## WILLIAM PATERSON UNIVERSITY

### **ADDENDUM NO 1**

TO: All Prospective Bidders  
DATE: March 31, 2025  
PROJECT: Recreation & Health Sciences Center Renovations & Additions -  
Construction (WP-23-01-29)

## 1 LEVEL 2 FRAMING PLAN

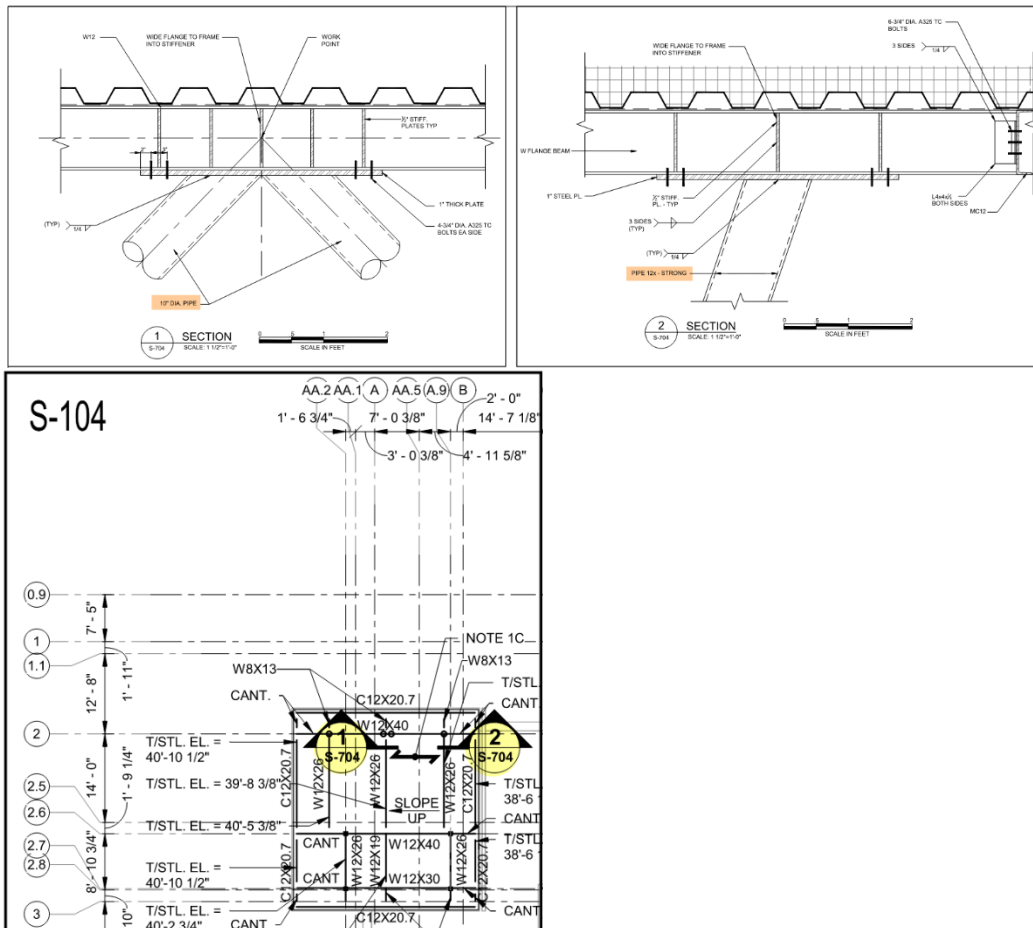
- A49. Detail B/S600 can be used where "CANT" is call out on plan off of a column. It is expected a minimum of 50% will need stiff plates
- Q50. (Question received two times) Re: LS-001**

**The chart below shows that the steel on this project will not be spray-fireproofed. Sheet 1/S-102 shows that the steel at this level will receive spray-on fireproofing. Please confirm that spray fireproofing will only apply at this level.**

A50. Note 1A applies to area identified on S-102 under the academic gymnasium only. Spray fireproofing is required at locations Defined by LS-103 at level 2 creating a horizontal separation under the Academic Gym room #207 only and is coordinated to S-102 location of note 1A. it is not required at full area of level 2
